Historic Preservation Design Review

August 28, 2014

HP-14-16, 13 N. Main St. – Naomi & Warner’s (City)

Request: Historic Preservation Design Review approval to alter the rear façade of 13 N. Main St. in order to open a retail establishment.

Below: A sketch done by RS Bell Architects showing the concept for the rear façade of the building.

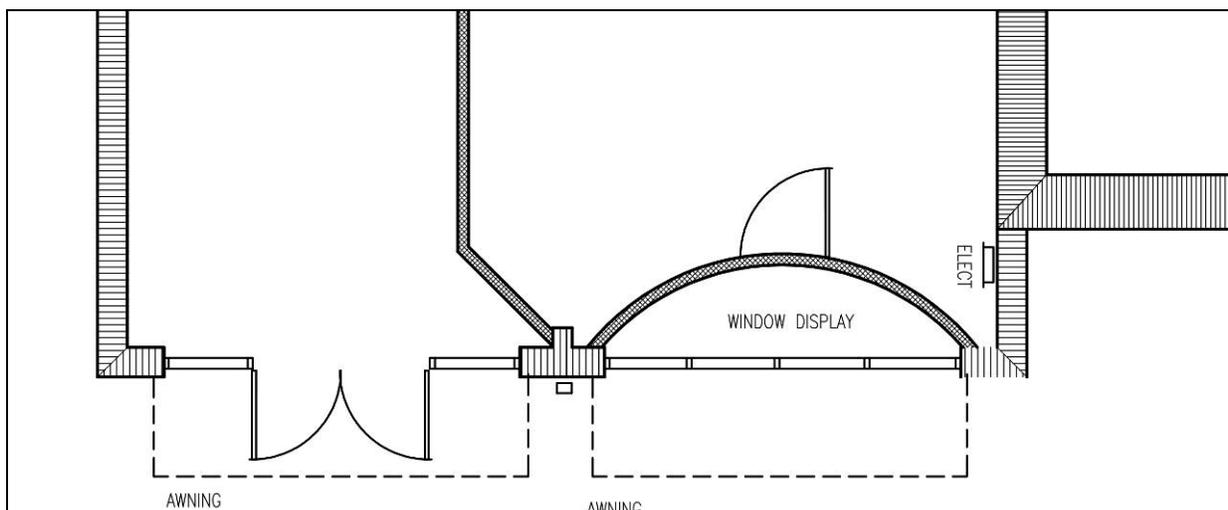
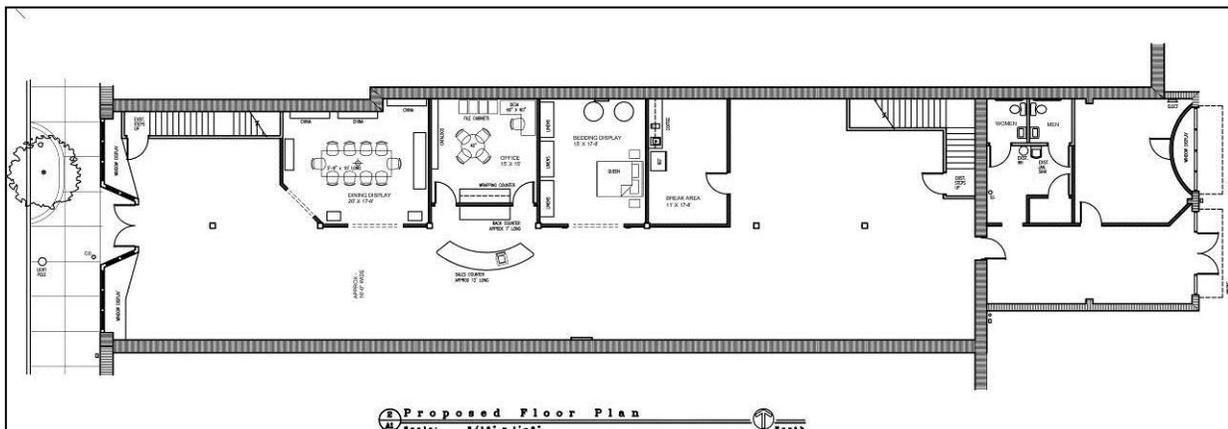
- This is an awning for the rear of the building. However, it will add interest and make the rear façade attractive and is therefore compatible with the district.

- The colors chosen for this project are subdued and are in keeping with the character of the district.

- The proposed windows and doors are to be an aluminum storefront type system with a double door entrance and a display window. These meet the criteria specified above, by being contemporary but understated so as not to compete with the surrounding historic architectural styles.

Staff has reviewed this request in accordance with the design guidelines. Staff recommends approval of this request.
